STAFF REPORT FOR THE PLANNING COMMISSION MEETING OF JANUARY 15, 2019

FILE NO: TPUD-18-010

AGENDA TITLE: For Possible Action: To consider a request for a tentative planned unit development that would create 156 multi-family units consisting of three four-plexes and 18 eight-plexes as well as 137 single family home lots. The multifamily development will be on land zoned Multi-Family Apartment (MFA), and the single family homes will be on land zoned Single Family 6,000 (SF6). The subject property is east of Interstate 580, west of Airport Road, and at the south end of Lompa Lane, APN 010-041-75, 010-036-05, and 010-542-01. (Hope Sullivan, hsullivan@carson.org)

A AIRPORT ROAD CROSS SECTION - 60' ROW - w/ PROPOSED SIDEWALK (PUBLIC)

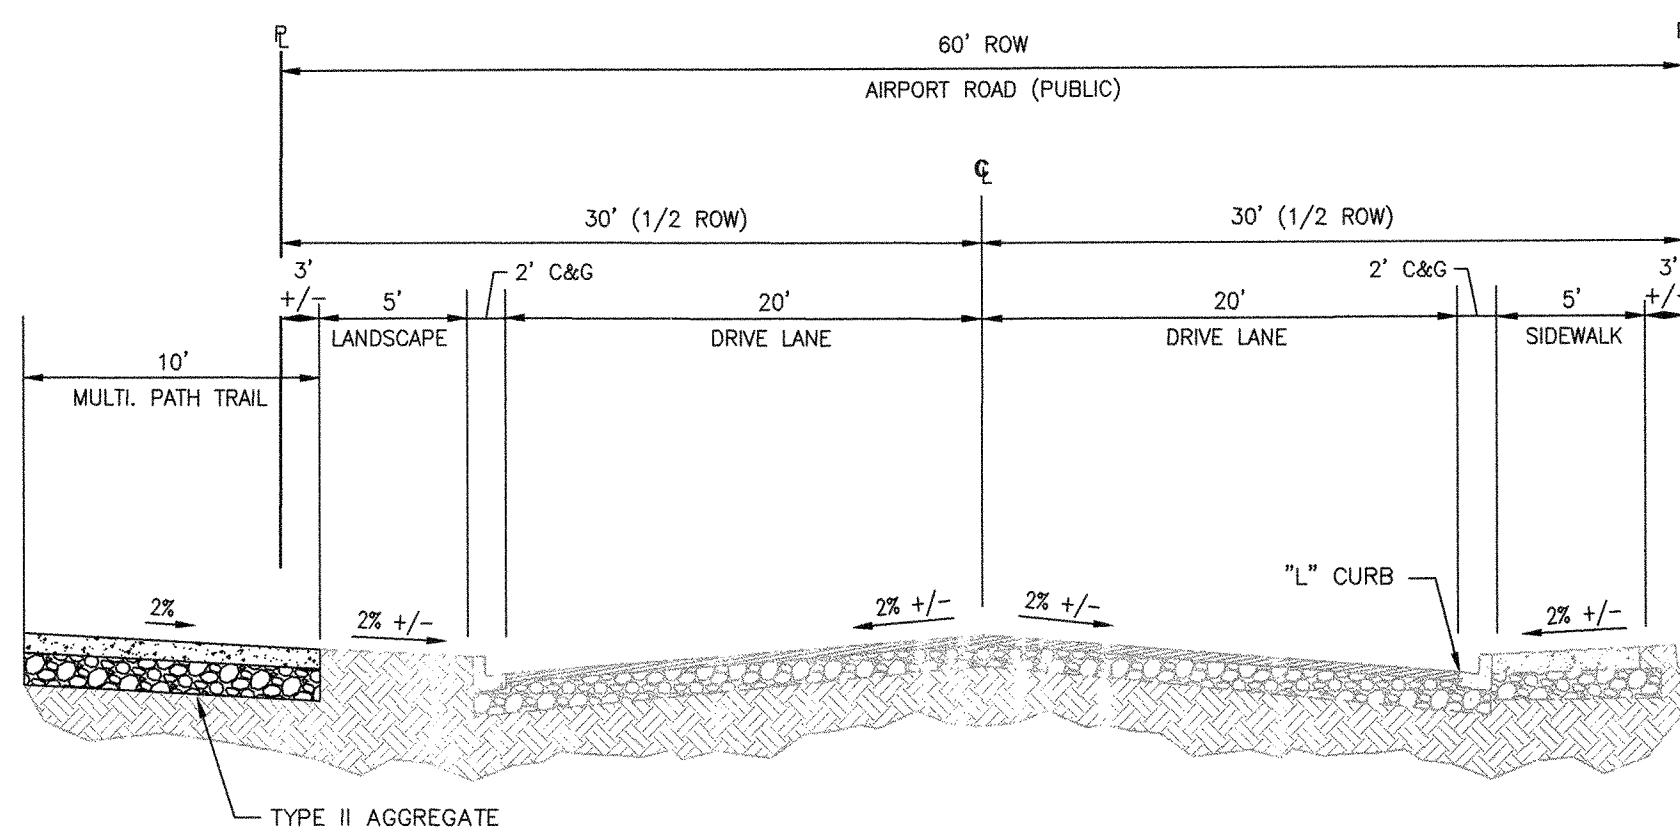
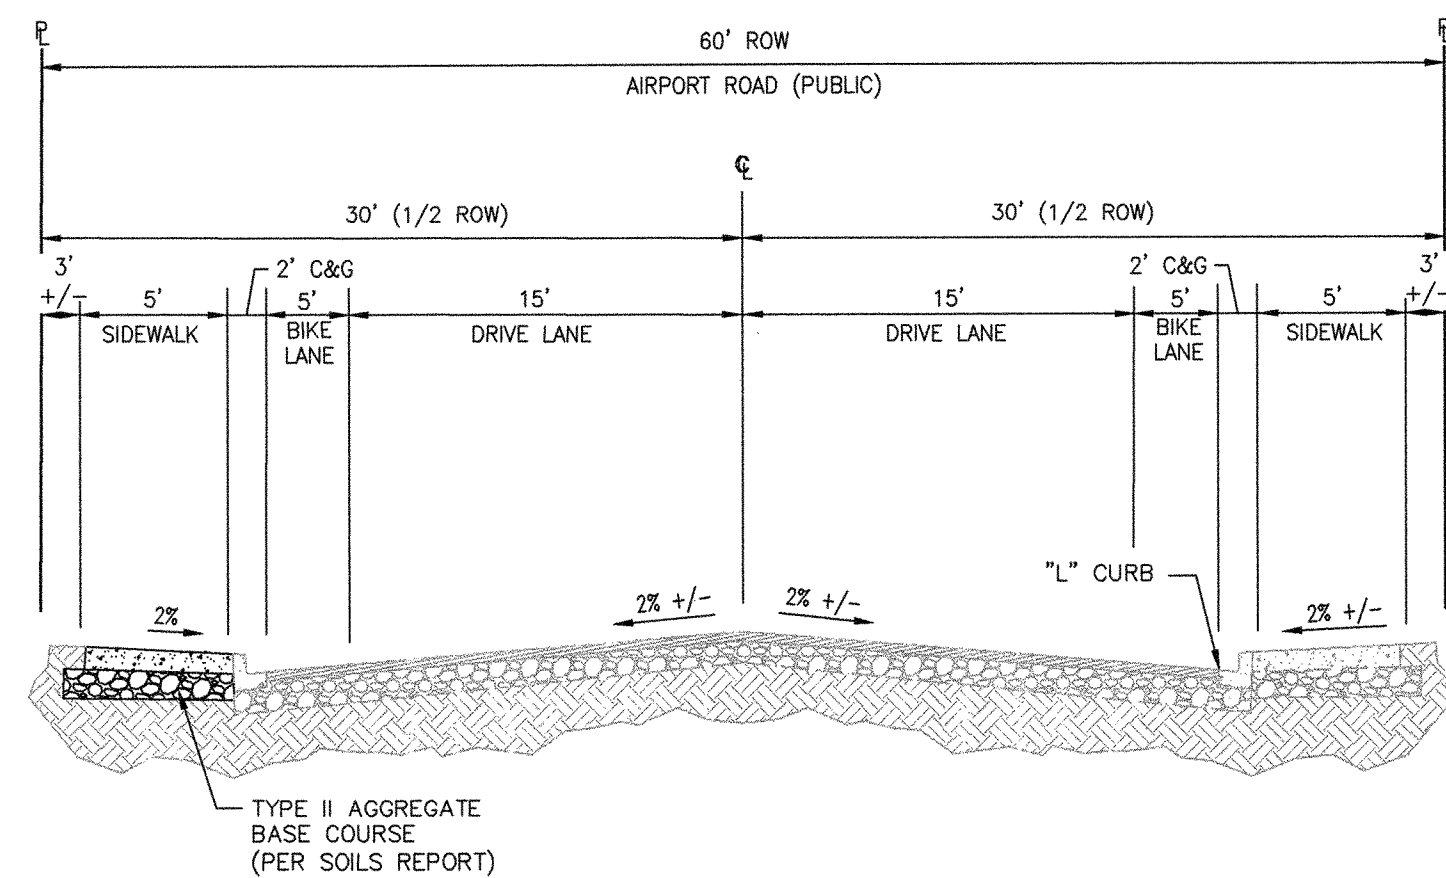
- Airport Rd must have "No Parking" signs posted along the frontage of the project on the west side of the street only, to allow existing residences to continue to utilize parking. Airport Rd must meet the City Standard Detail for an urban collector with bike lanes and parking on one side. Airport Rd must be widened anywhere that the street does not meet the minimum width for the number of lanes per the Standard Details.

47. Airport Rd must have "No Parking" signs posted along the frontage of the project on the west side of the street only, to allow existing residences to continue to utilize parking. Airport Rd must meet the City Standard Detail for an urban collector with bike lanes and parking on one side. Airport Rd must be widened anywhere that the street does not meet the minimum width for the number of lanes per the Standard Details.

D LOMPA LANE w/MULTI TRAIL CROSS SECTION - 60' ROW (PUBLIC)

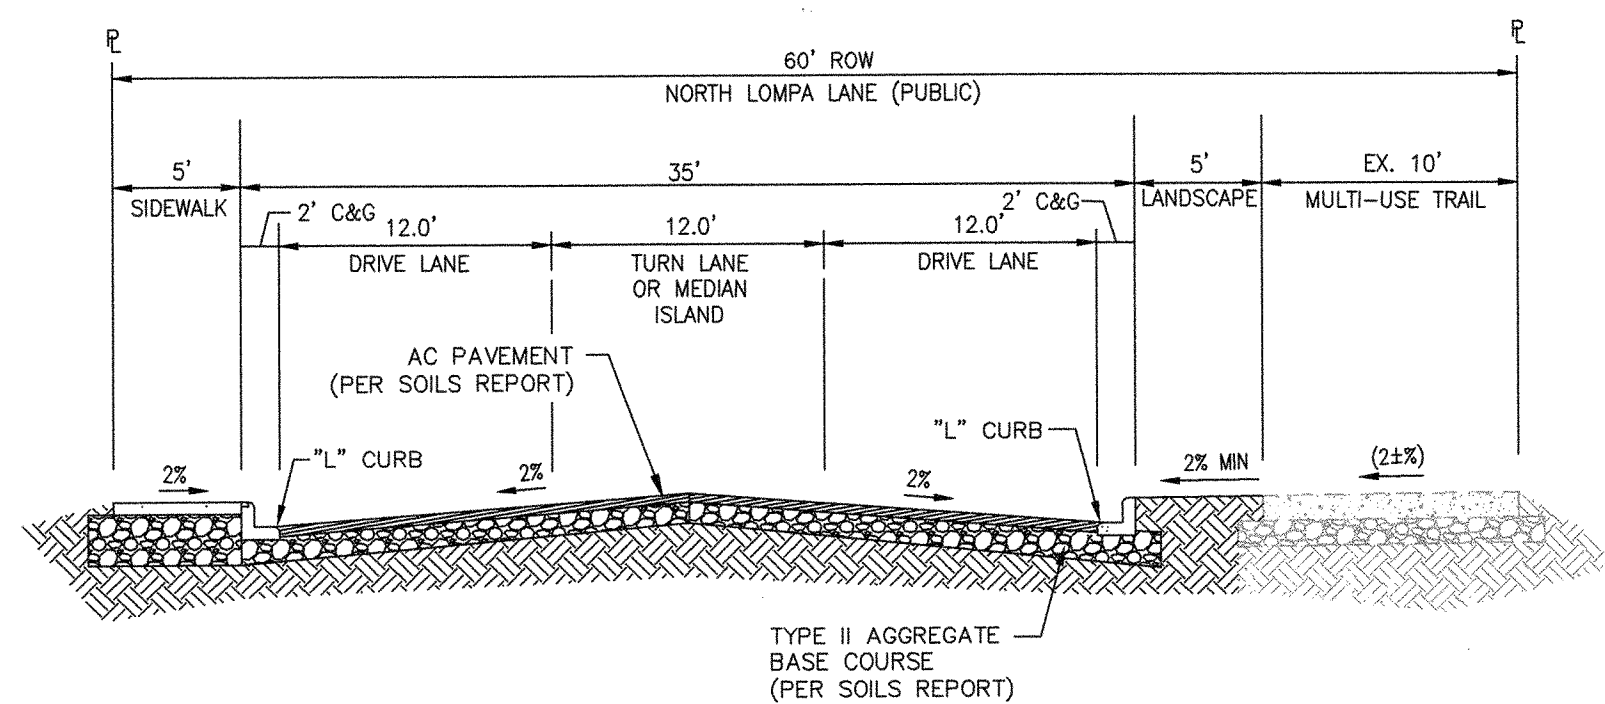
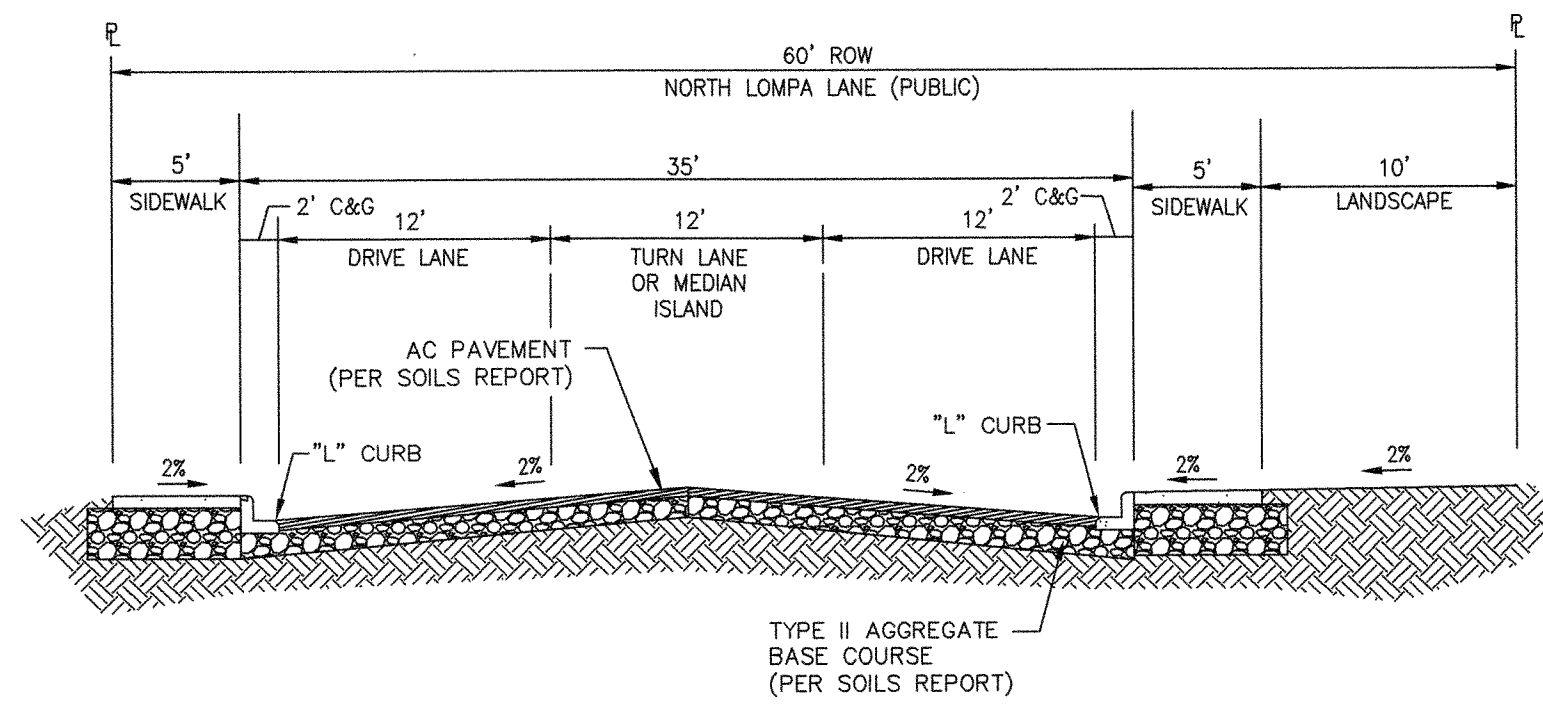
- The street section shown for N Lompa Ln is not wide enough to include an open channel for drainage. It is likely that a channel will be needed to perpetuate drainage along N Lompa Lane. In these areas the street section must be widened to include the drainage channel. It should also be noted that the existing multi-use path is on City owned property and will not be part of the right-of-way in question.

improvement plans must include a separate street section detail for this segment of the street, and the transition from the standard crown to the superelevation must be designed with a smooth transition.

52. The street section shown for N Lompa Ln must be wide enough to include an open channel for drainage where necessary in the opinion of the City Engineer. It is likely that a channel will be needed to perpetuate drainage along N Lompa Lane. In these areas the street section must be widened to include the drainage channel. It should also be noted that the existing multi-use path is on City owned property and will not be part of the right-of-way in question.

53. Per CCDS, the curve in N Lompa Lane must have a superelevation of 4%. The site improvement plans must include a separate street section detail for this segment of the street, and the transition from the standard crown to the superelevation must be designed with a smooth transition.
